Access Compliance Report Public Rights-of-Way (Curb Ramps)

Main Street: BEACH_BLVD Cross Street: MCFADDEN_AVE Location: NE

ADA ID: RPRK211005144226 Ramp Type: Type 1 - Perpendicular Diagonal Initial Pass/Fail: Fail Overall Compliance: No Severity Score: 15

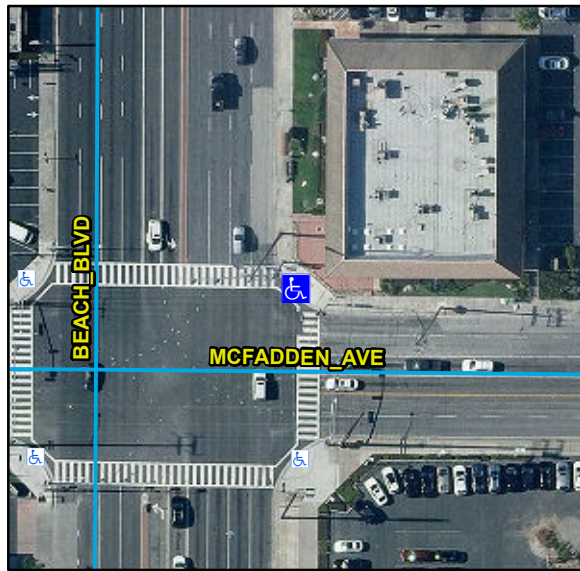
Compliance	Description	Data	Compliance	Description	Data
N/A	Ramp Length (in)	96	N/A	Flare Type LT	
Yes	Ramp Width (in)	48			N/A
No	Ramp Run Slope (%)	8.6	N/A	Flare Slope LT (%)	N/A
Yes	Ramp Cross Slope (%)	0.2	N/A	Flare Traversable LT	N/A
N/A	Landing Present	N/A	N/A	Flare Type RT	
N/A	Landing Length (in)	N/A			N/A
N/A	Landing Width (in)	N/A	N/A	Flare Slope RT (%)	N/A
N/A	Landing Run Slope (%)	N/A	N/A	Flare Traversable RT	N/A
N/A	Landing Cross Slope (%)	N/A	N/A	DWS Provided	N/A
N/A	Landing Movement Obstructed?	N/A	N/A	DWS Contrast	N/A
	Landing Movement Type	N/A	N/A	DWS Length (in)	N/A
N/A	Landing Shared	N/A	N/A	DWS Full Width	N/A
N/A	Clear Space	Yes	N/A	DWS Offset Left (in)	N/A
N/A	Clear Space To Crosswalk (in)	48	N/A	DWS Offset Right (in)	N/A
N/A	Marked Crosswalk 1	Yes	N/A	Marked Crosswalk 2	Yes
	Crossing 1 Direction	W		Crossing 2 Direction	S
	Marked Crosswalk 1 Width (in)	140		Marked Crosswalk 2 Width (in)	140

N/A	Ramp Inside Crosswalk 1	No	Yes	Ramp Inside Crosswalk 2	No
	Crossing 1 Slope (%)	10.3		Crossing 2 Slope (%)	4.6
	Crossing 1 Cross Slope (%)	2.2		Crossing 2 Cross Slope (%)	0
N/A	Gutter Ponding	N/A	No	Curb Slope	11.6
Yes	Gutter Lip Height (in)	0		Road Run Slope (%)	3.7
N/A	Gutter Run Slope (%)	N/A		Road Cross Slope (%)	6.1
N/A	Gutter Cross Slope (%)	N/A			
Yes	Overall Surface Condition: Acceptable		Yes	Perp Joint Present	Yes
	Cross Gutter Present?	No		Spandrel Present?	No
	Replace Cross Gutter?	N/A		Replace Spandrel?	N/A

Remove & Replace Curb Ramp With Two New Directional Ramps or Equivalent. Restripe Crosswalk.
